Re: RFCA Guardrail Test

Picco Engineering has completed our review of the test performed by Infrastructure Health & Safety Association for the temporary guardrail strength.

Residential Temporary Floor Guardrail Testing

| DWG. TITLE | | TEMPORARY FLOOR GUARD DETAIL | | 1 | 11/12/2015 | ISSUED FOR CONSTRUCTION | | |

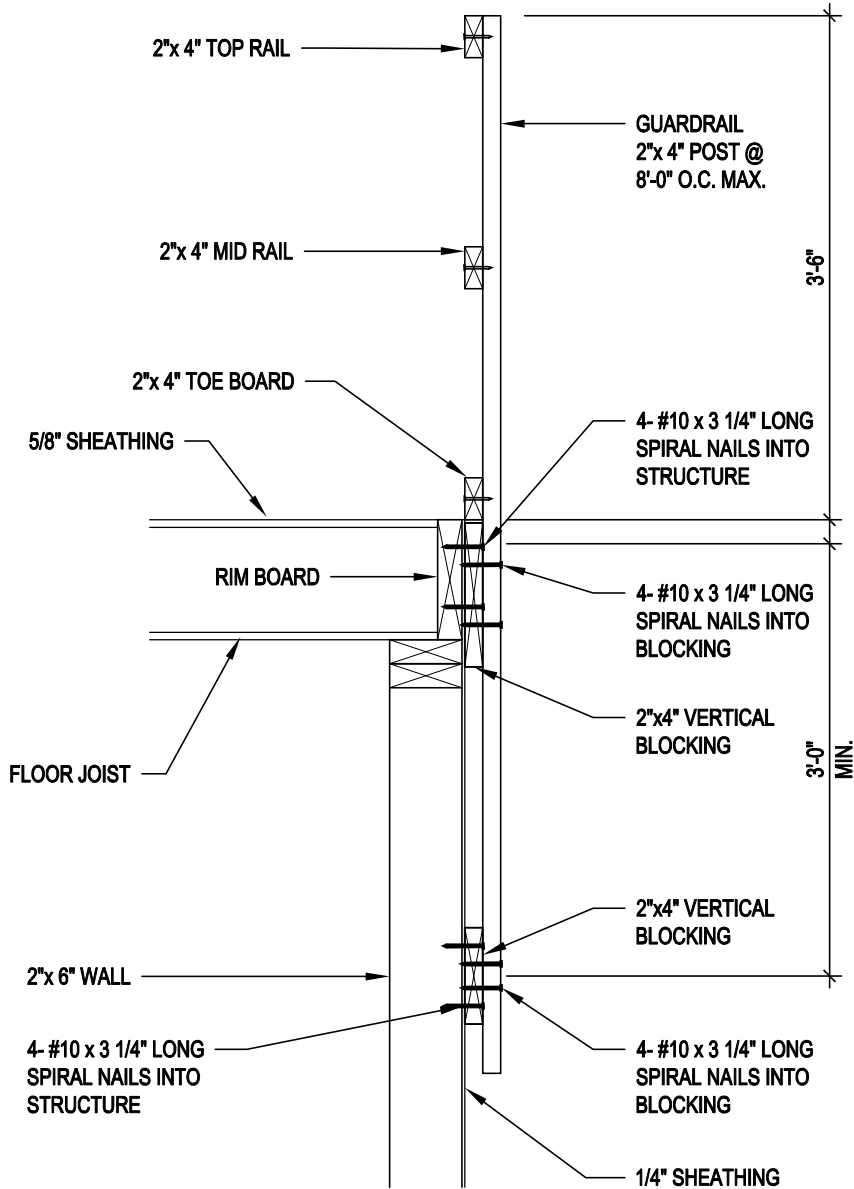
Based on the results of this testing and the successful historic use of these railings, it is our opinion that the temporary railing is acceptable. This acceptance is contingent that the installation on site meets or exceeds the requirements of the details provided in SK-7a by Picco Engineering dated December 11, 2015 and the assembly tested. The guardrail must be constructed in strict conformance to the detail provided.
